ADDENDUM NO. 1
to
CONTRACT DOCUMENTS

for
ADDITIONS AND RENOVATIONS
to the
PRINCETON MIDDLE SCHOOL
located at 217 Walnut Lane, Princeton, NJ 08540

Issued: January 15, 2026

FVHD PROJECT NO. 5516B

Drawing Number
A105

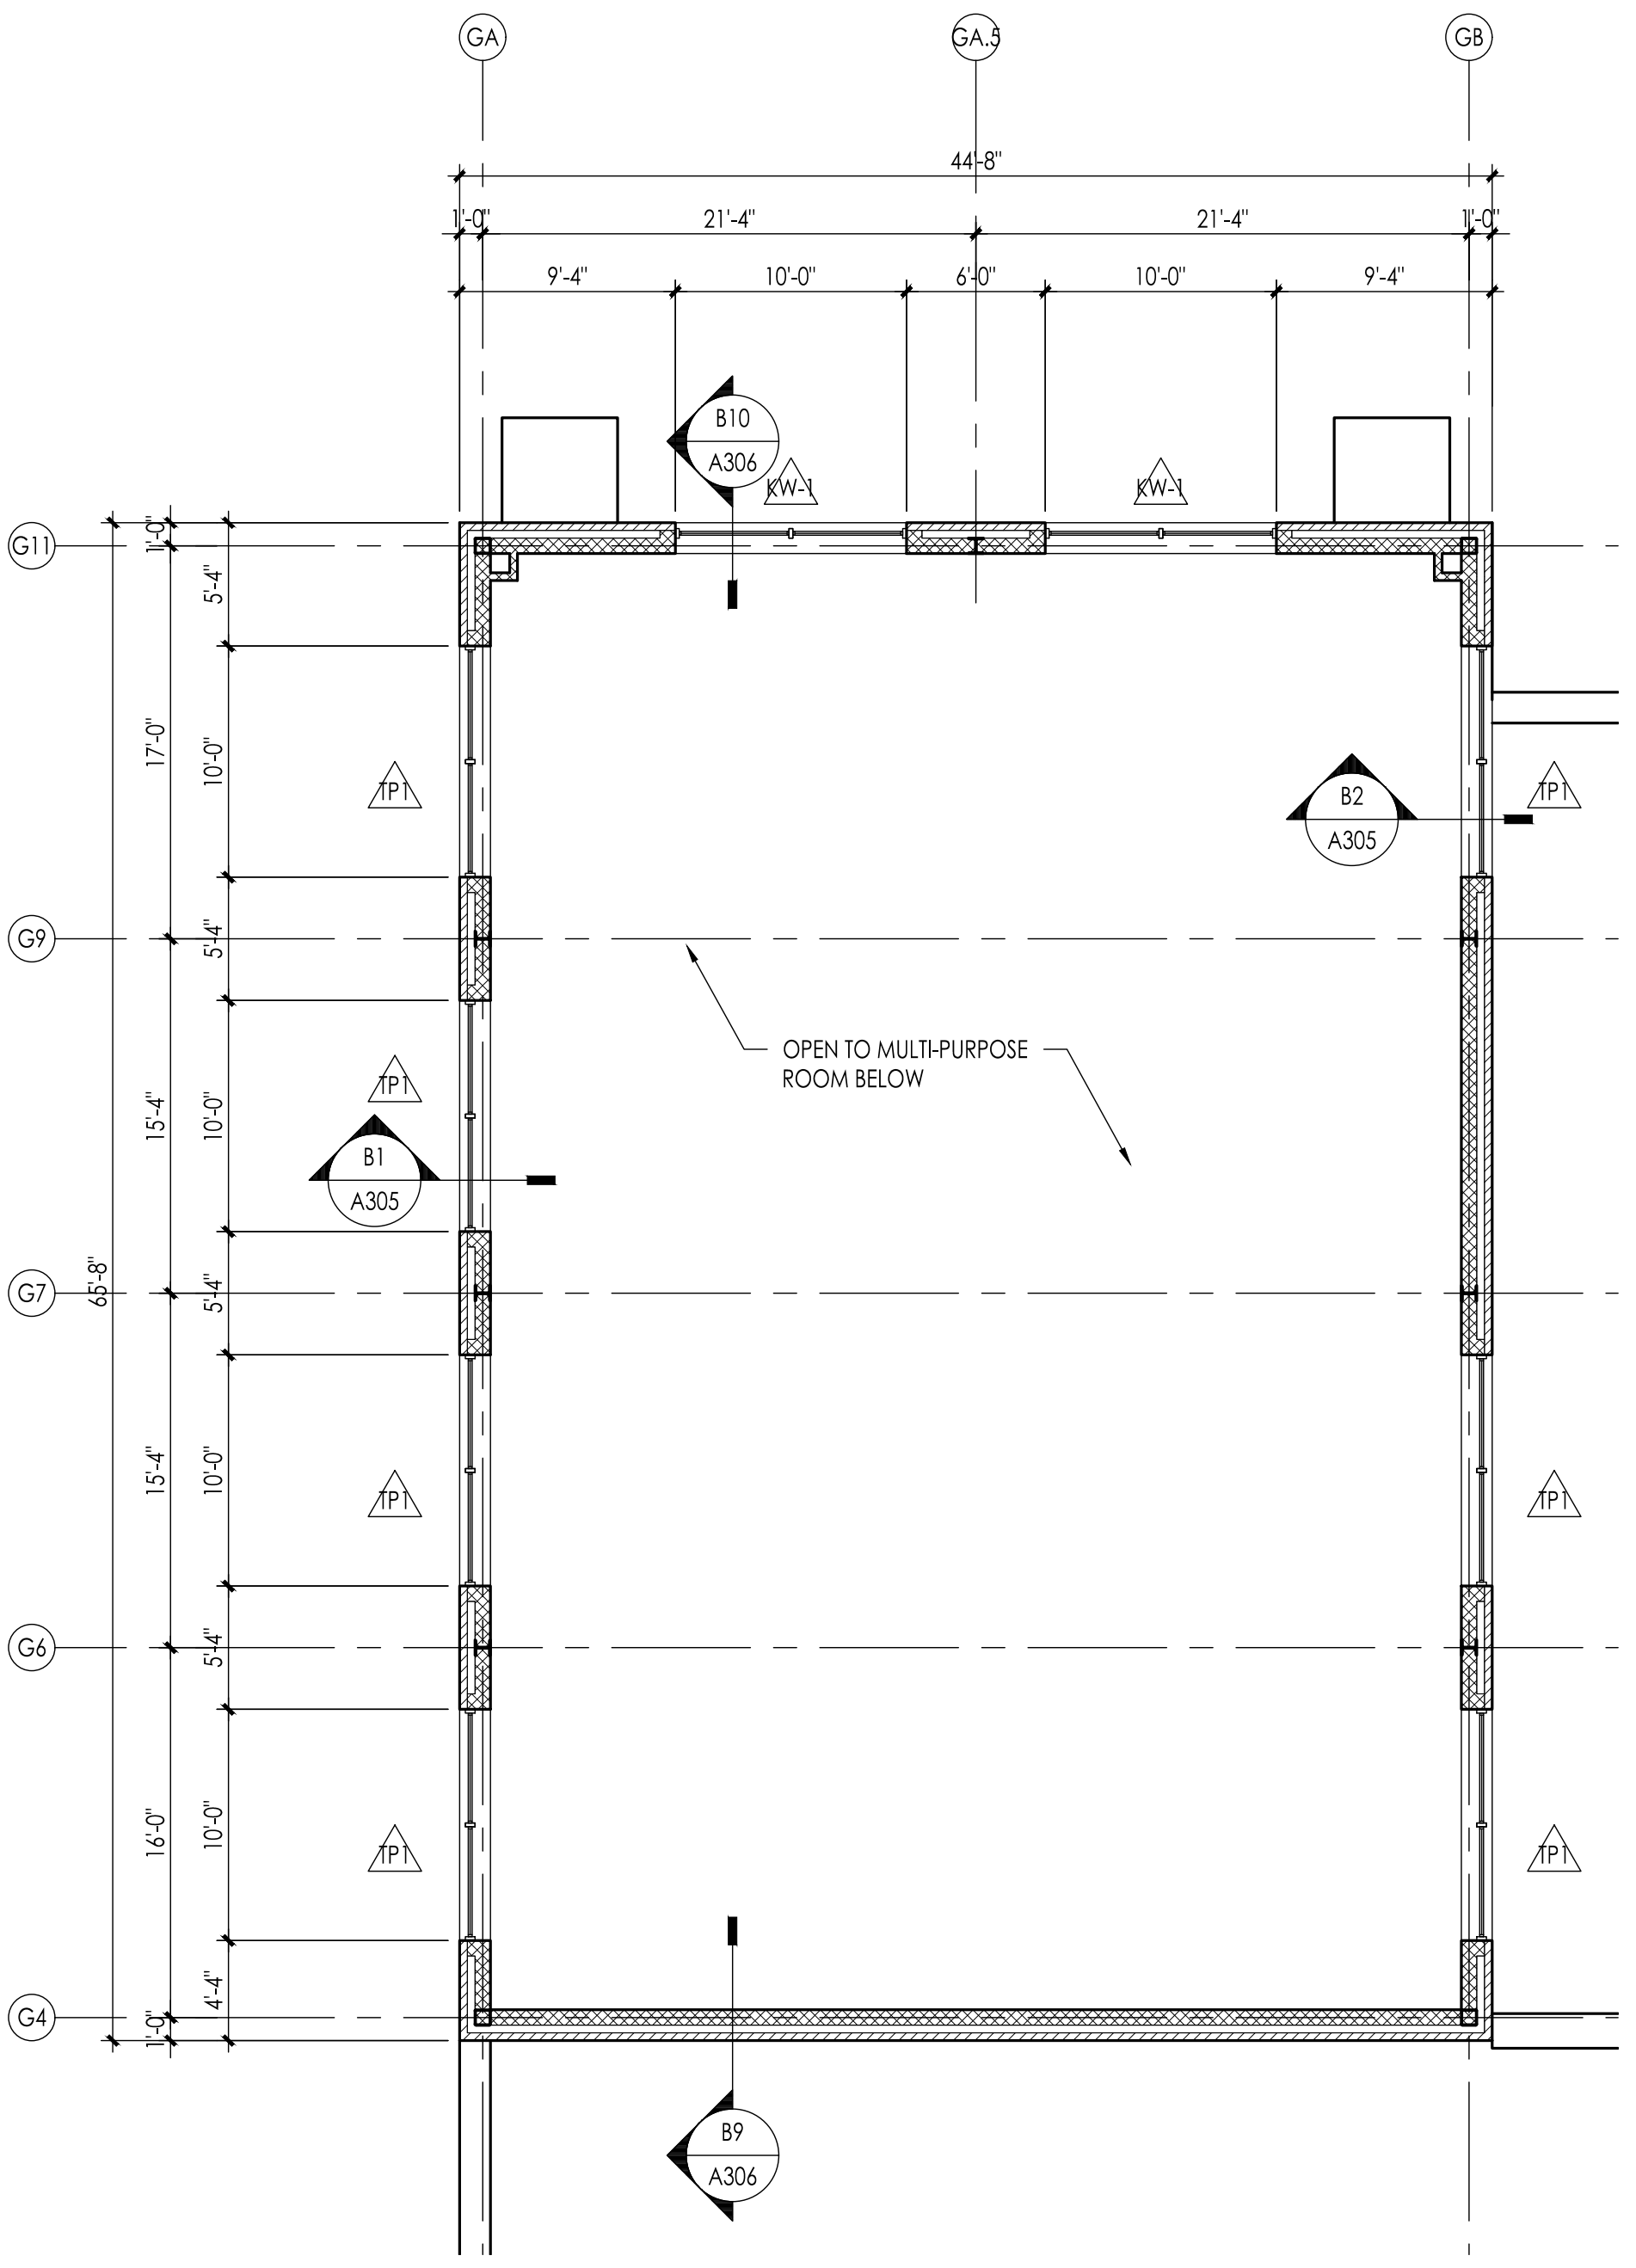
10. Question: Please confirm location of Overhead Doors, Specifications included, not on plans.

13. Question: "Pocket doors" – Specifications include pocket doors, pocket doors are NOT shown on drawings. Please confirm if they are to be included for all units.

Response: Location and details are added to the drawings. See revised A105, A306, A601 and A602, attached to this Addendum.

Response: Pocket doors are required at the recesses where the folding partitions are stacked when not deployed. See revised A103, A104 and A105, attached to this Addendum.
